Bentley Bulletin

21-037

Subject: RECALL CAMPAIGN – Bentley 21MY Bentayga Rear Axle Trailing Arm Lock Nut (RE20/21)

Topic	Rear axle lower lever (right and left) Inner and outer nut replacement (RE21/17)
Market area	Australia E04 Bentley rest Asia and Australia (6E04),China 796 VW Import Comp. Ltd (Vico), Beijing (6796),Germany E02 Bentley rest Europe (6E02),Japan E03 Bentley Japan (6E03),United Arab Emirates E06 Bentley Middle East and Africa (6E06),United Kingdom E01 Bentley UK (6E01),United States E05 Bentley USA and rest America (6E05)
Brand	Bentley
Transaction No.	2063114/1
Campaign number	RB98
Note	
Type	
US code

Figure 1

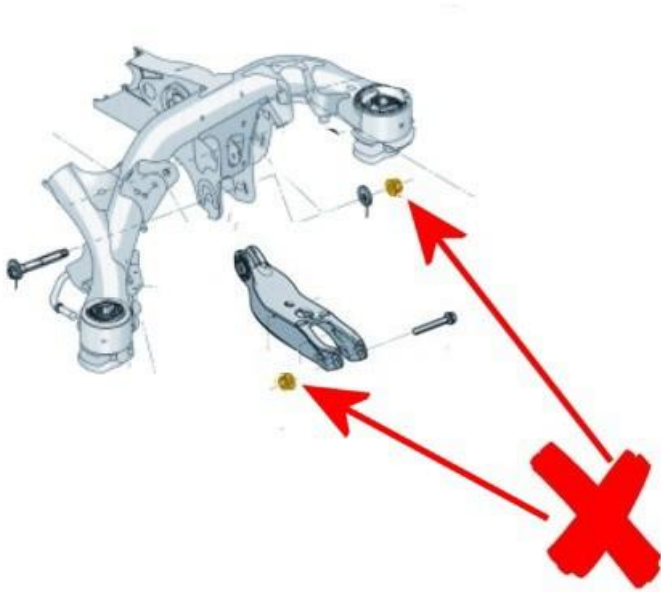
All vehicles require replacement of the original (WHT 007 610) left and right hand rear axle lower lever inner and outer nuts (x4)

A new specification part (WHT 010 234) is now available, the inspection of the original nuts (Figure 1) prior to removal is imperative as this will confirm if any other components require replacement.

Replacement of WHT 007 610 (x4) nuts is mandatory on all vehicles

NOTE: For photographic purposes Figure 1 shows one side only

Replacement of the left and right hand lower rear axle lever nuts (x4) is required due to a potential fracturing issue, the issue has been identified as a possible concern on a very low number of vehicles

Figure 1

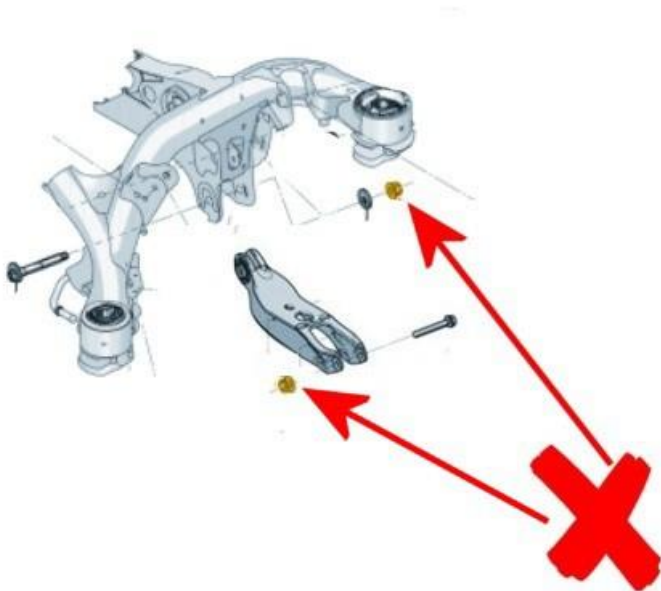
All vehicles require replacement of the original (*WHT 007 610*) left and right hand rear axle lower lever inner and outer nuts (x4)

A new specification part (*WHT 010 234*) is now available, the inspection of the original nuts (Figure 1) prior to removal is imperative as this will confirm if any other components require replacement.

■
Replacement of *WHT 007 610* (x4) nuts is mandatory on all vehicles

NOTE: For photographic purposes Figure 1 shows one side only

- Set the vehicle in "Jack" mode and position the vehicle on a wheel free ramp
- Discharge the air from the left and right air spring dampers - Refer to "Air suspension system - To discharge and charge".
- Carry out a visual inspection of the left and right hand rear lower lever inner and outer nuts (x4) as Figure 1 IMPORTANT: Check for fracturing or signs of reduced torque, see the example shown in Figure 2 of a fractured nut
